**CITY OF SAINT PAUL
HERITAGE PRESERVATION COMMISSION STAFF REPORT**

FILE NAME: 594 Selby Avenue/156 Dale Street

DATE OF PUBLIC HEARING: March 9, 2020

CLASSIFICATION: New construction

SETBACKS

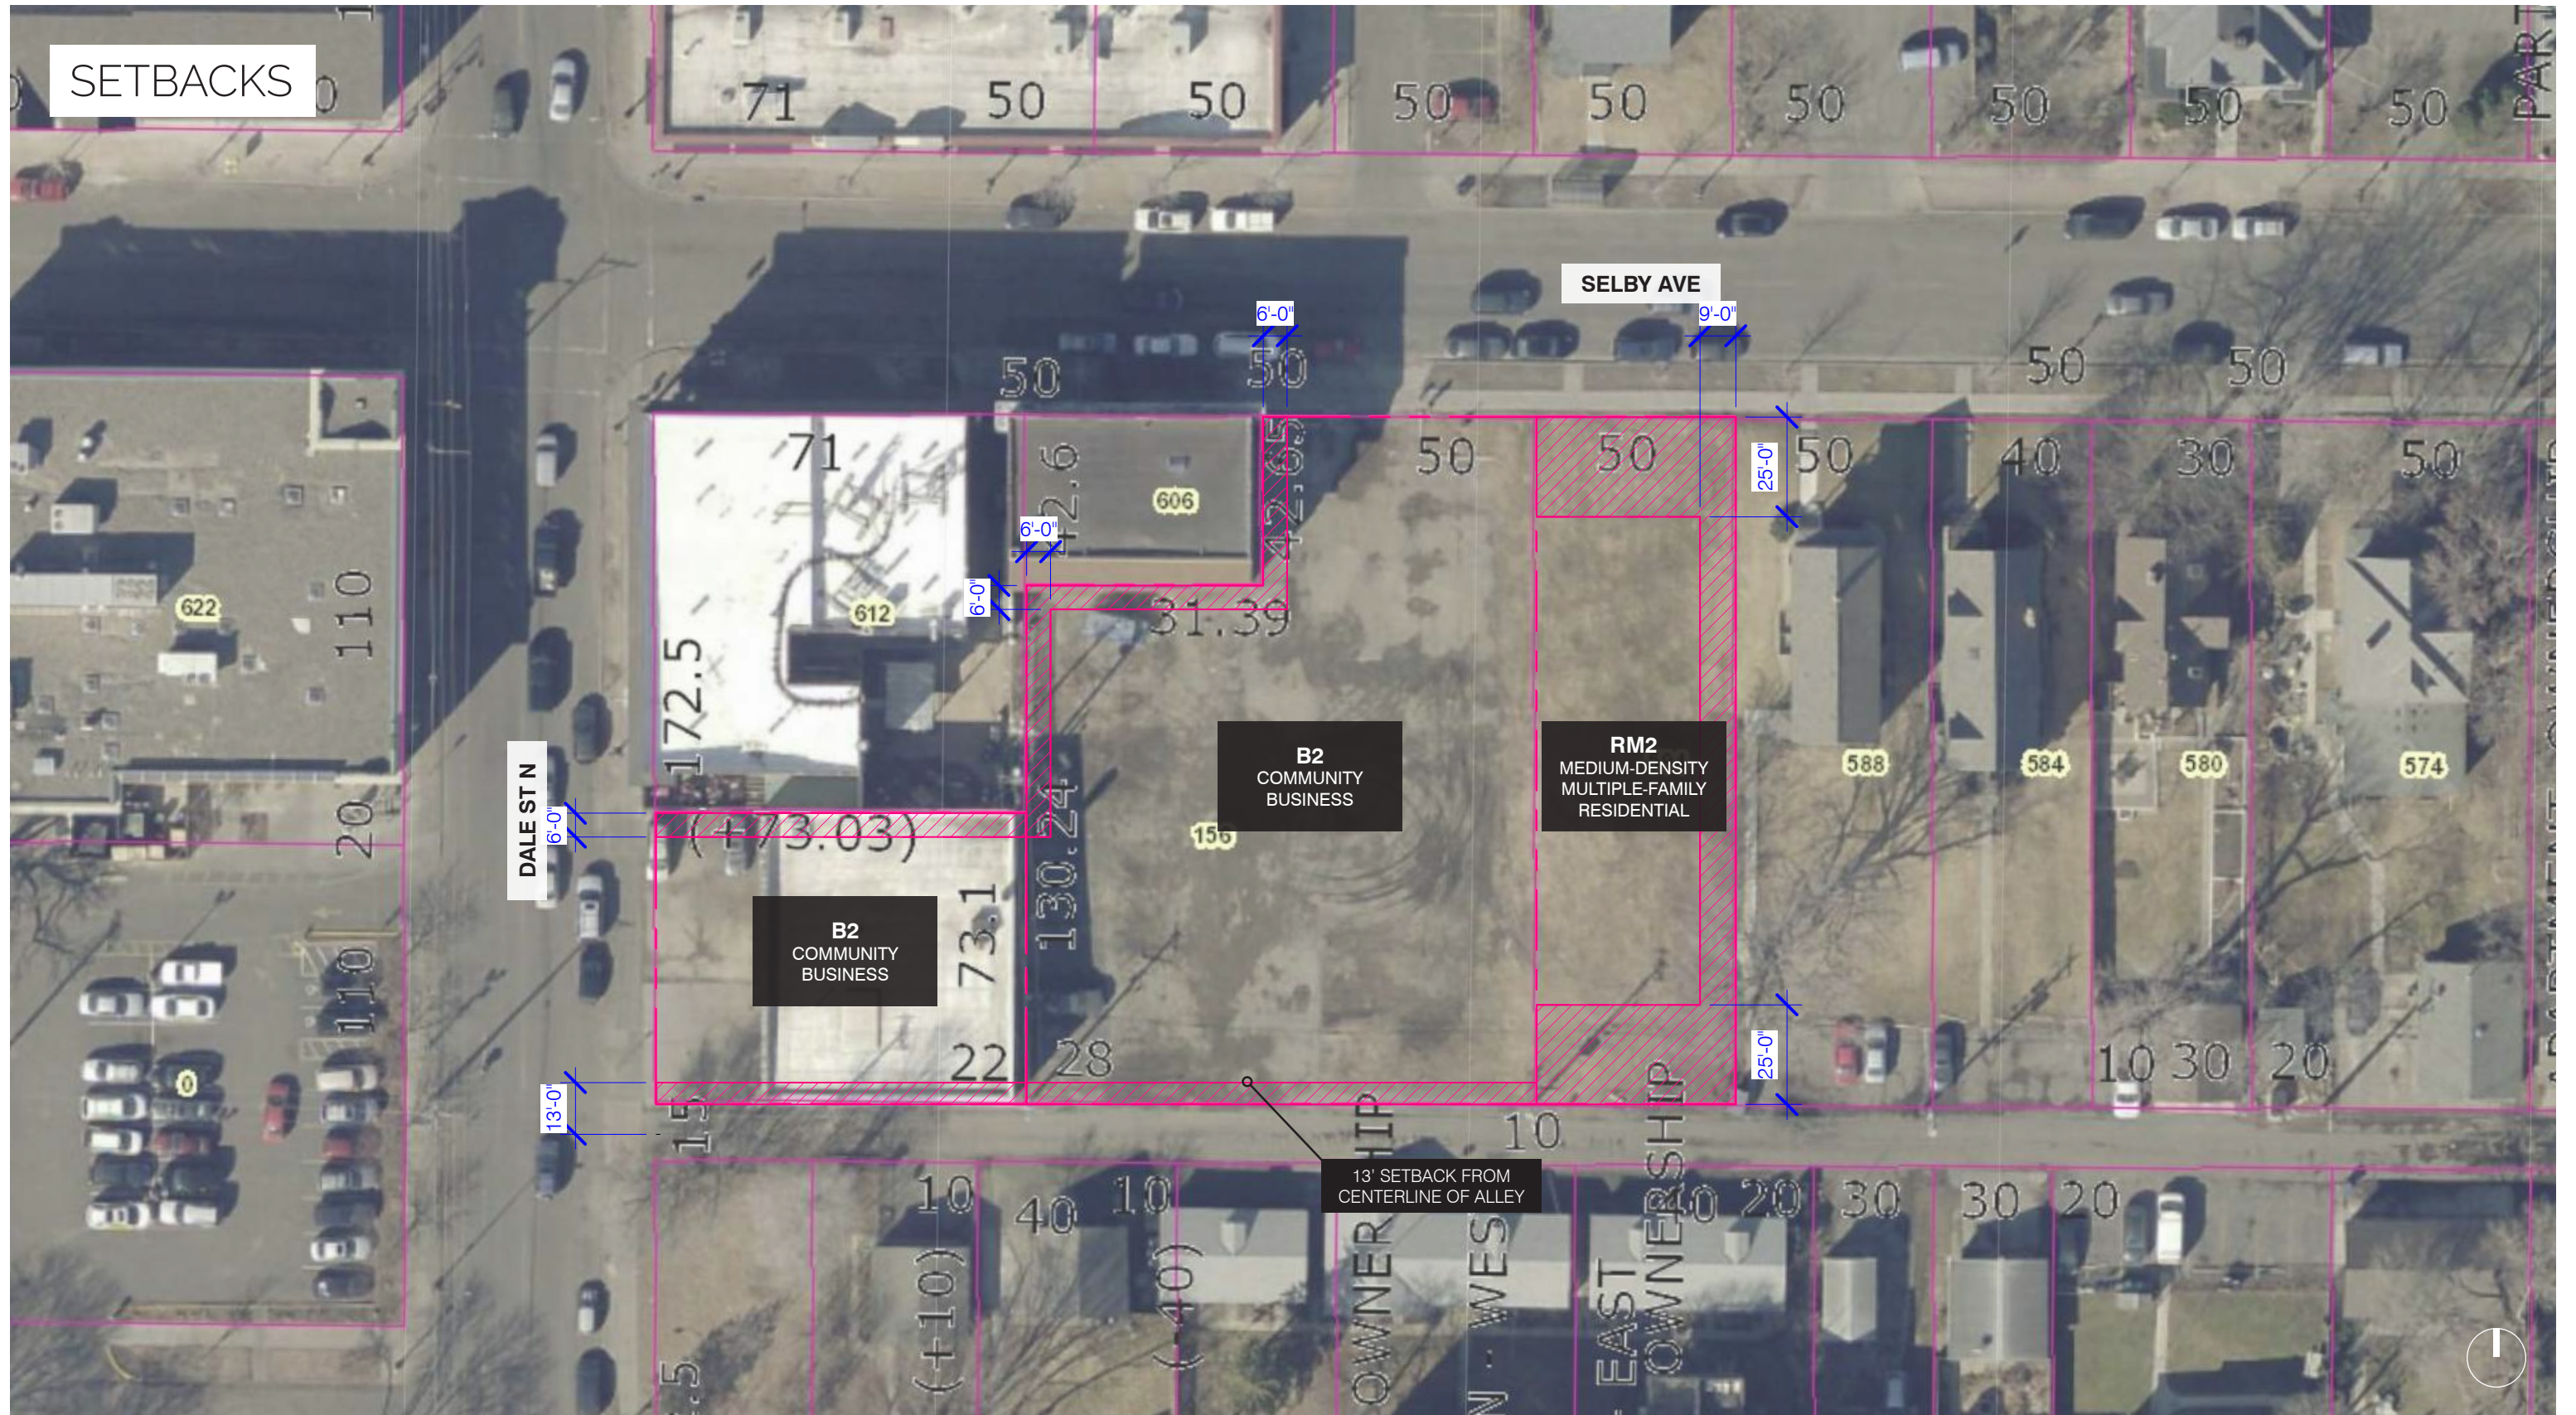
<p>(f) <i>Site:</i></p> <p>(1) <i>Setback.</i> New buildings should be sited at a distance not more than five (5) percent out-of-line from the setback of existing adjacent buildings. Setbacks greater than those of adjacent buildings may be allowed in some cases. Reduced</p>	Yes	The setbacks relate to both the commercial and residential properties surrounding the new construction.

BUILDING MATERIALS

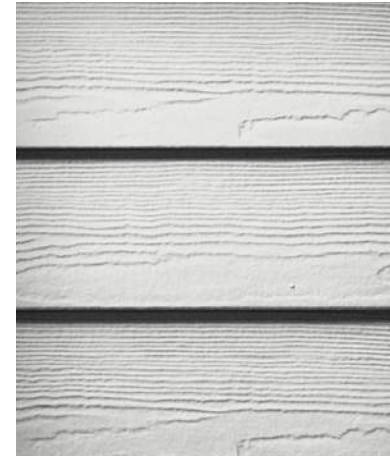
<p>(d) <i>Material and Details:</i></p> <p>(1) Variety in the use of architectural materials and details adds to the intimacy and visual delight of the district. But there is also an overall thread of continuity provided by the range of materials commonly used by turn-of-the-century builders and by the way these materials were used. This thread of continuity is threatened by the introduction of new industrial materials and the aggressive</p>	Yes/No	<p>The proposed brick and fiber cement lap siding are appropriate for the district, however, the fiber cement lap siding should be smooth. Also, the proposed fiber cement shake siding style does not relate to the district and should be explored further.</p>
